PHILADELPHIA ELECTRIC COMPANY

SUBJECT: NUREG-0737 Item II.F.1.4 Containment Pressure Monitor  
Item II.F.1.5 Containment Water Level Monitor  
Item II.F.1.6 Containment Hydrogen Monitor

RE: Peach Bottom Atomic Power Station

SUBJECT: Request for Additional Information  
NUREG-0737. Items II.F.1.4, 5 and 6  
Peach Bottom Atomic Power Station Units 2 and 3

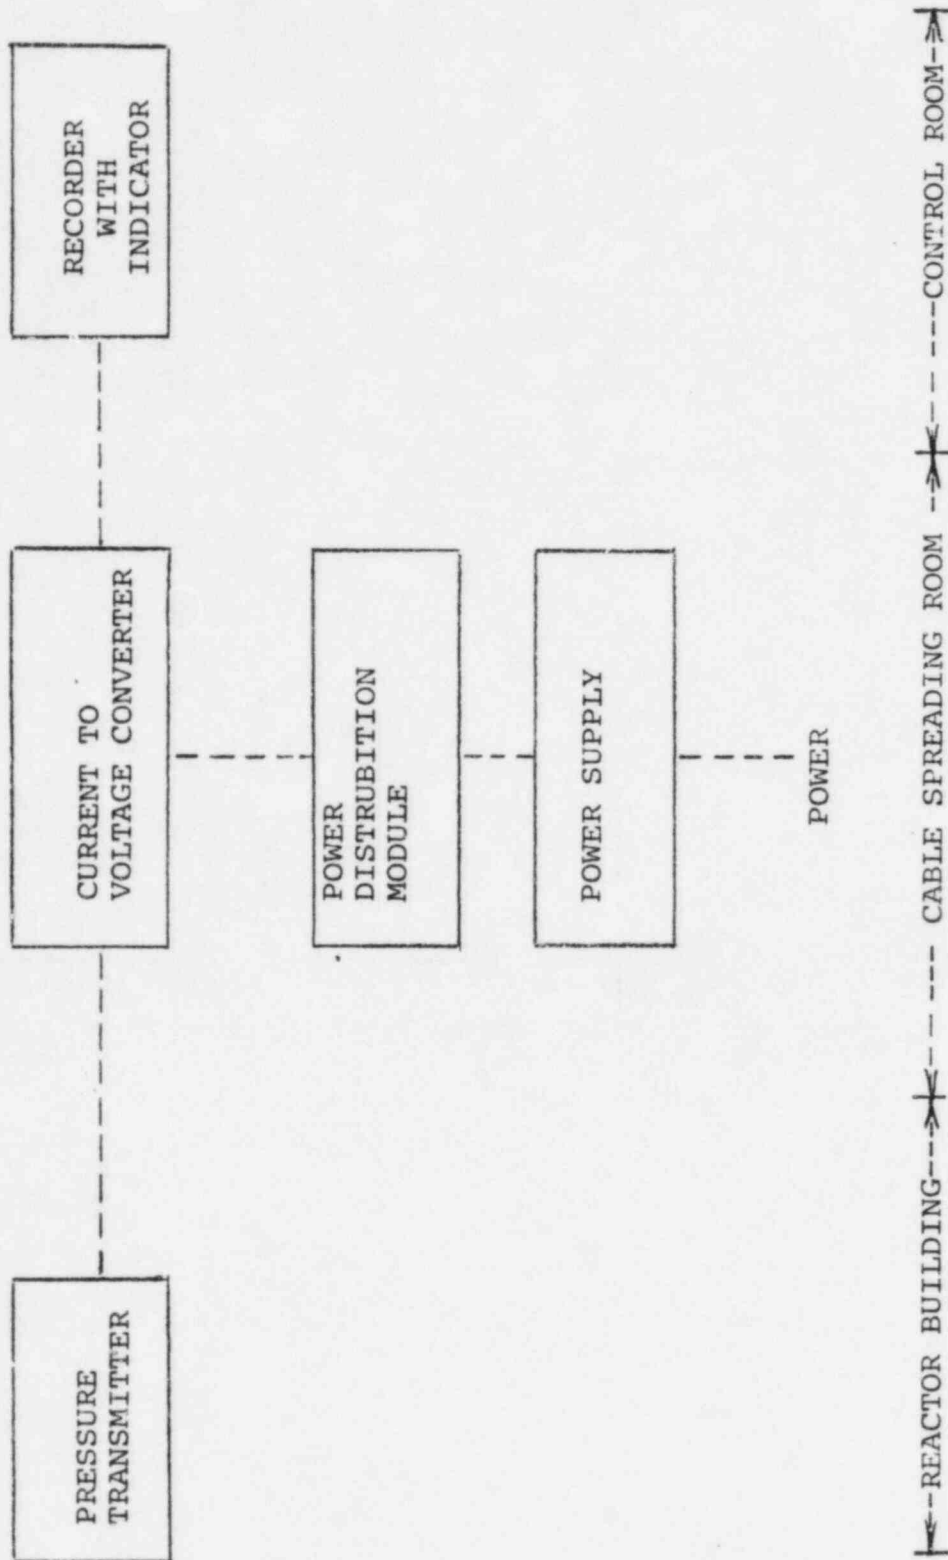
(4d) Indicate the placement and number of hydrogen monitor intake ports in containment. Indicate any special sampling techniques that are used either to examine one region of containment or to assure that a good cross section of containment is being monitored.

(4d) Redundant analyzers are provided to monitor hydrogen concentration in each drywell and torus. Samples are withdrawn through primary containment penetrations at the following elevations:

drywell: El. 127'-2"  
drywell: El. 199'-9"  
torus: El. 125'-0"  
torus: El. 114'-0"

Since the primary containment is not compartmentalized, except into drywell and torus, multiple sample points within the containment compartments for each analyzer are not considered necessary. An analysis of the effectiveness of combustible gas mixing within the PBAPS primary containment is included in FSAR Supplement 1, Response to Question 14.6.

FIGURE 1

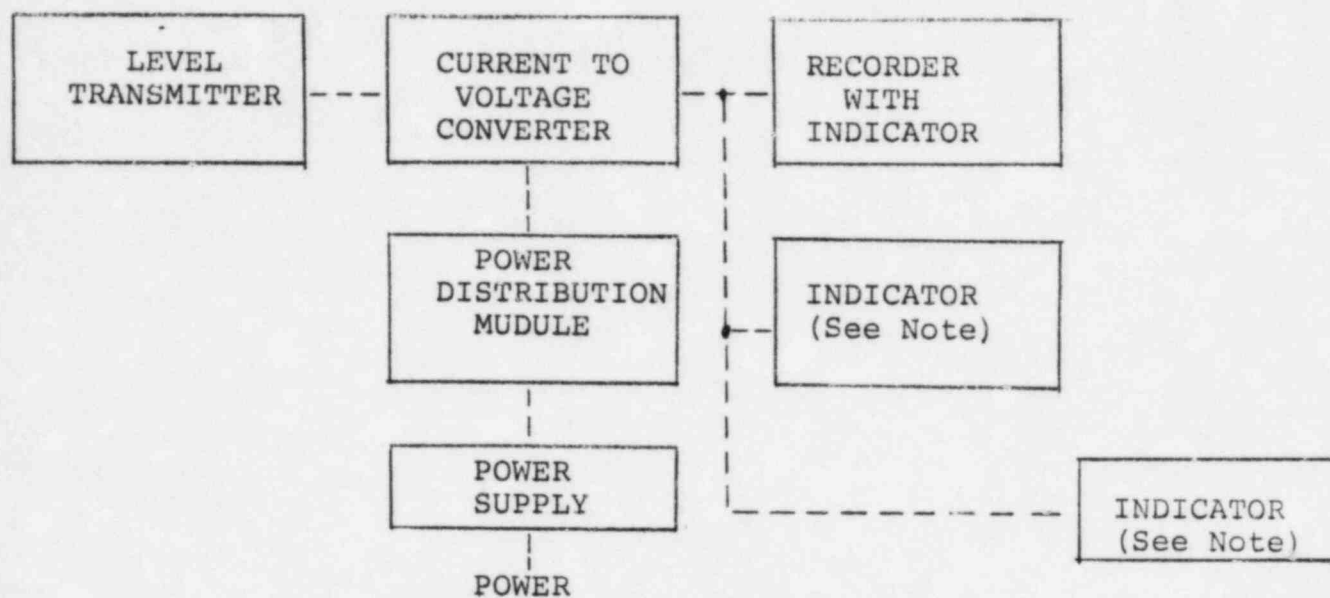
- (2a) Provide a block diagram of the configuration of modules that make up your PMS. Provide an explanation of any details in the block diagram that might be necessary for an understanding of your PMS accuracy and time response.

- (2a) See figure 1 for a block diagram of the configuration of modules that make up the containment pressure monitoring system. There are four instrument loops, two with a range of 0 to 225 psig and two with a range of 5 to 25 psia. The power for the instrument loops and the power to run the recorders is provided from the power supply through the power distribution module.

FIGURE 2

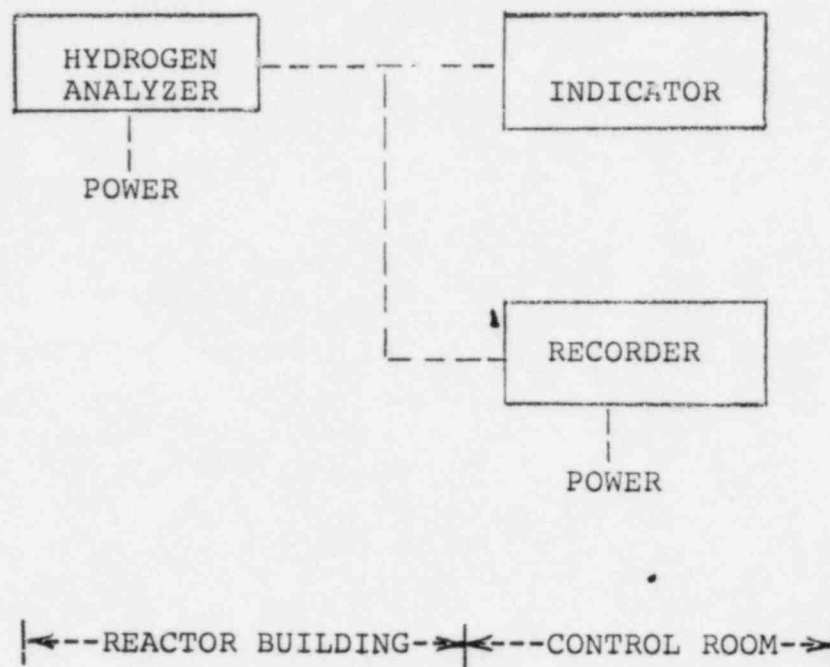
- (3a) Provide a block diagram of the configuration of modules that make up your WLMS. Provide an explanation of any details in the block diagram that

might be necessary for an understanding of your WLMS accuracy.

- (3a) See figure 2 for a block diagram of the configuration of modules that make up the suppression pool water level monitoring system. There are two suppression pool water level instrument loops, each with a range of 1 foot to 21 feet from the bottom of the suppression pool. The power for the instrument loops and the power to run the recorders is provided from the power supply through the power distribution module.
